**NUMBER:** 23-016-19 REV. A

Battery Acid Leaking on Transmission Pan

This bulletin involves replacing the battery tray drain pipe, adding a battery vent pipe, battery vent cap and clamps.

RAM ProMaster City

Fig. 3  
Clip and New Battery Tray Vent Pipe

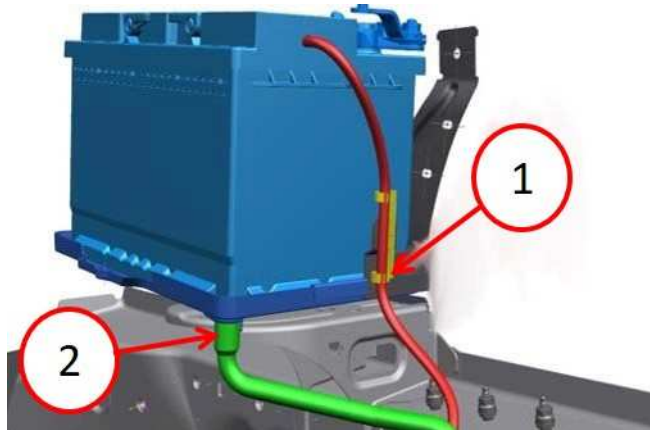
7. Install new battery tray drain pipe **P/N 68417800AA** on the battery tray (Fig. 3) .

8. Install clip **P/N 68476190AA** (Fig. 4) on the battery tray bracket (Fig. 3) .

9. Fasten the battery vent pipe **P/N 68476284AA** on clip **P/N 68476190AA** (Fig. 3) .
10. Install the battery strap and fuse junction box. Refer to the detailed service procedures available in DealerCONNECT/Service Library under: Service Info>08 - Electrical/8F - Engine Systems/Battery System/Battery/Installation.

Fig. 5  
Clamp on Body Hole

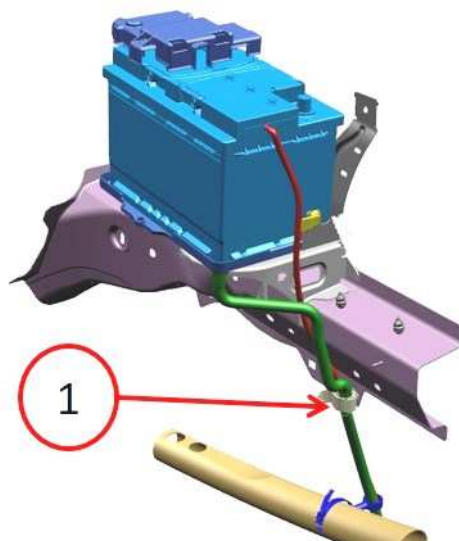
13. Install clamp **P/N 68163243AA** into the body hole (Fig. 5) near the transmission.

Fig. 8  
Clamp on Radiator Support Beam

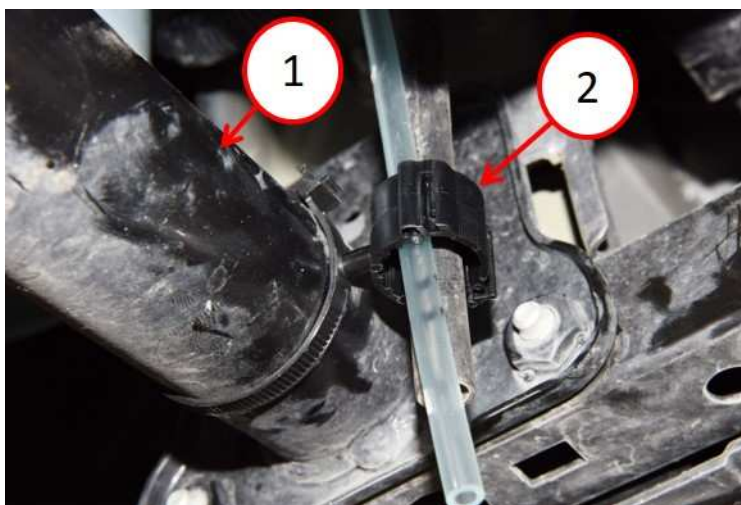
16. Secure the band from clamp **P/N 68461928AA** to the round cradle and radiator support beam (Fig. 8) .

**Fig. 15**  
**New Battery Vent Pipe Routing and Clamps**

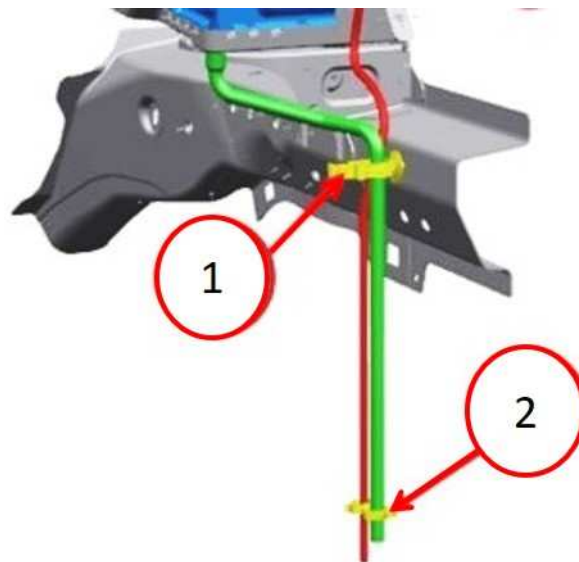
8. Position both pipes downward pointing to the ground (Fig. 15) .

**Fig. 17**  
**P/N 68112893AA Clamp Measurement Locations**

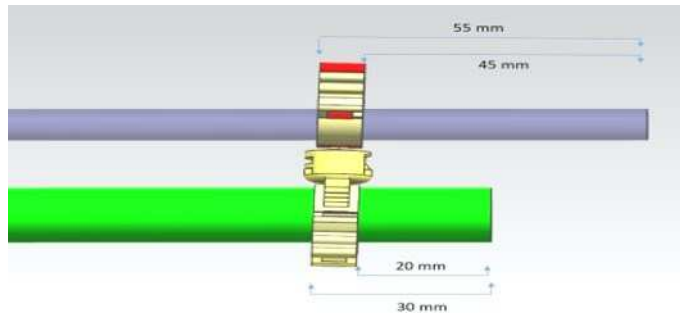
11. Install **P/N 68112893AA** clamp (Fig. 16) on both pipes between 20 - 30 mm (.78 - 1.18 in.) on the tray drain pipe and between 45 - 55 mm (1.77 - 2.16 in.) from the end of the battery drain pipe (Fig. 17) and (Fig. 18) .
